SUBJECT: US Wind Maryland Offshore Wind Project LOA – Proposed Rule Comment Responses

The following are responses to the comments received from NMFS regarding the Letter of Authorization (LOA) Proposed Rule for the Maryland Offshore Wind Project on October 6, 2023.

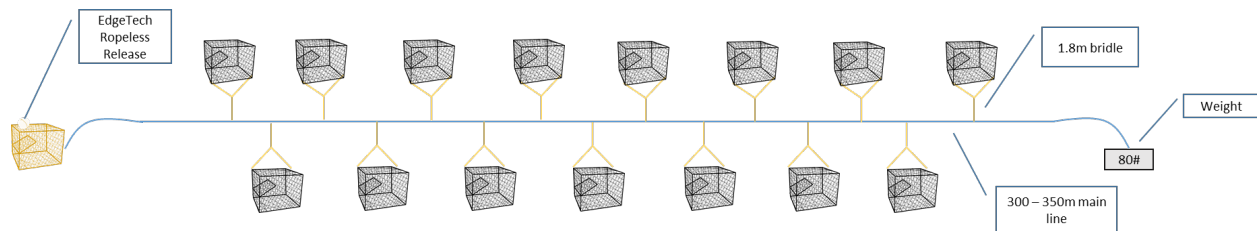
**NMFS Comment:** What vessel types will be used during operations and maintenance? What is the max number of operation and maintenance vessels and the expected maximum annual number of trips?

- US Wind Response:** Representative vessel types would include fall pipe vessels, crew transfer vessels, jack-up vessels, a sportfisher, and multi-role survey vessels. The maximum number of operation and maintenance vessels is anticipated to be 10; however, not all vessels would be operating at the same time. Four of the vessels indicated below would be for non-routine basis and would not operate every year, if at all, Crew transfer vessels unlikely to operate on a daily basis year-round; for conservative purposes daily trips are assumed. Preliminary information concerning vessel trips was initially provided in Table 1-3 of the LOA application and has been updated here to reflect the best estimates at this time.
